ADDENDUM # 3

RE: **RFIs #1 and #2, along with corresponding responses**
Contract ID: DN00545
County: Cherokee
Letting Date: November 15, 2016

RFI: 001 JOB: Cherokee County Rest Area

CHEROKEE COUNTY REST AREA

SKI

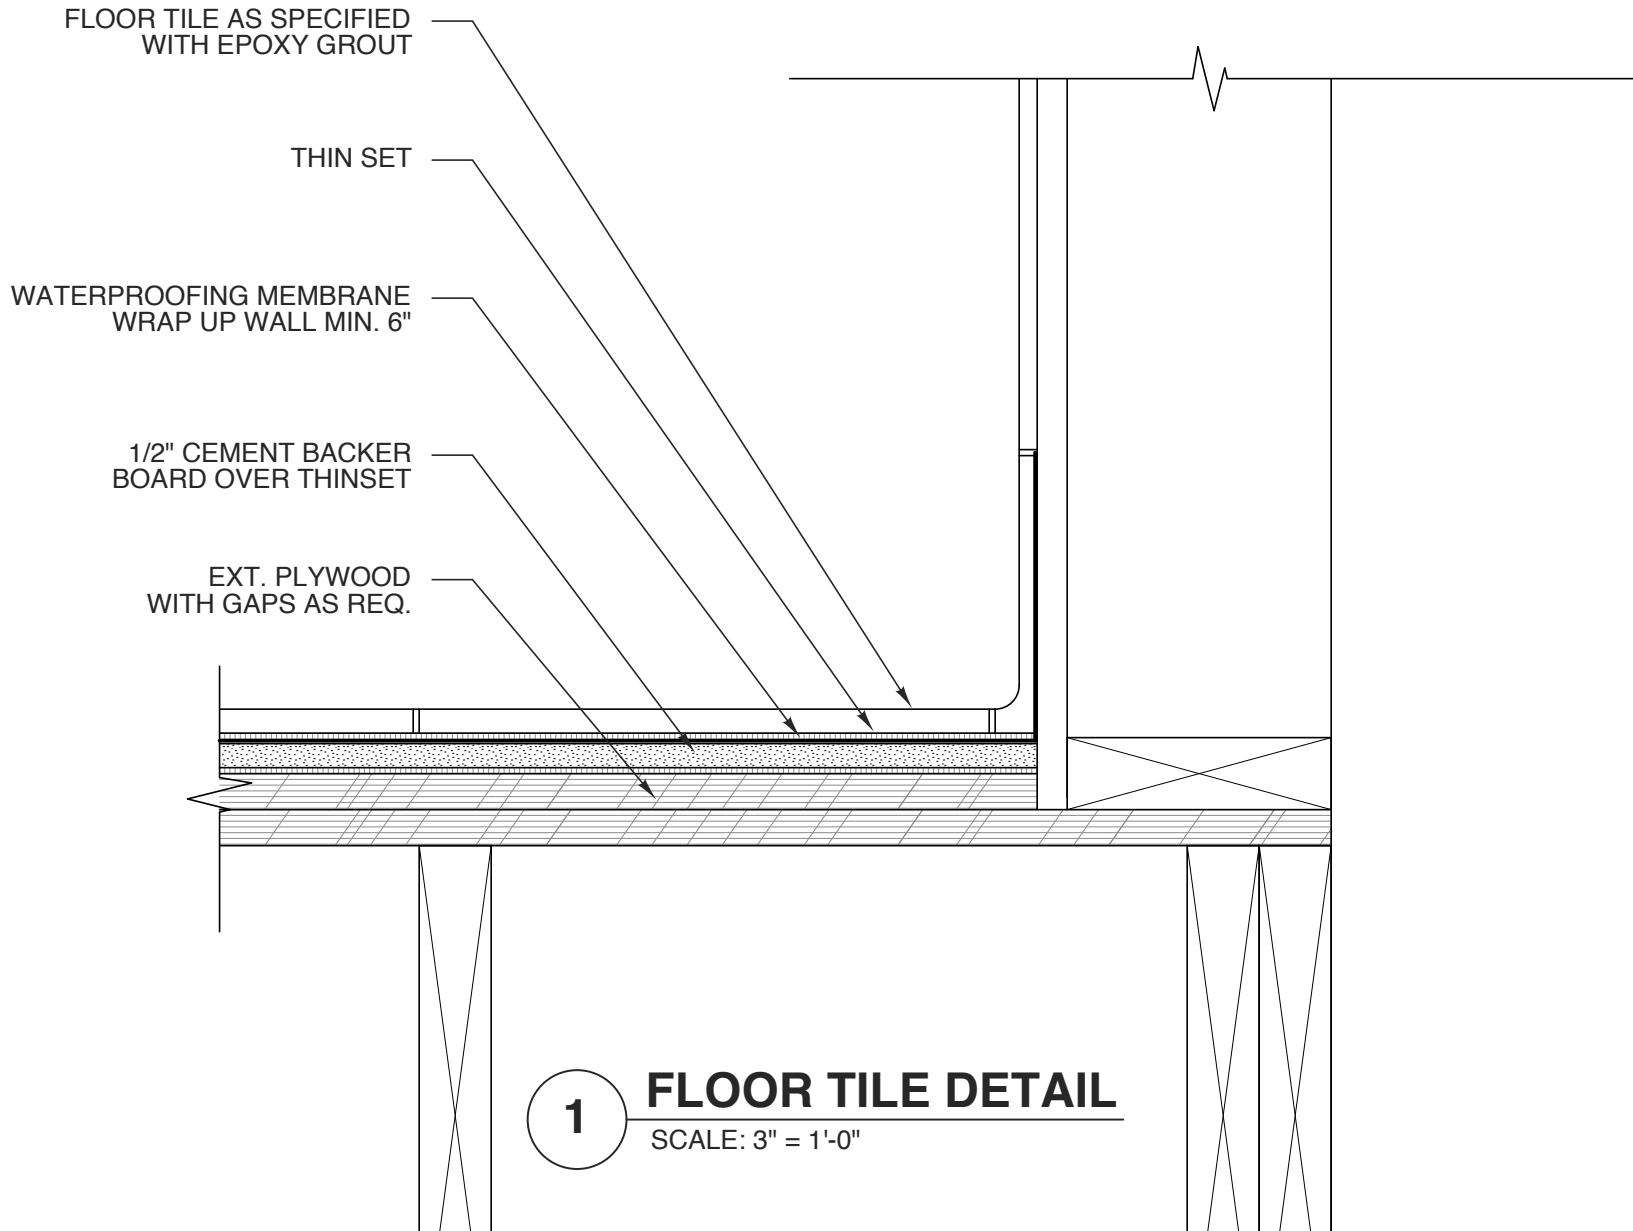
I: Reference Detail 2/A4.1 – This detail shows tile underlayment over the plywood subfloor. Are backer-board and waterproofing to be installed?

- I. See attached detail on SK1.
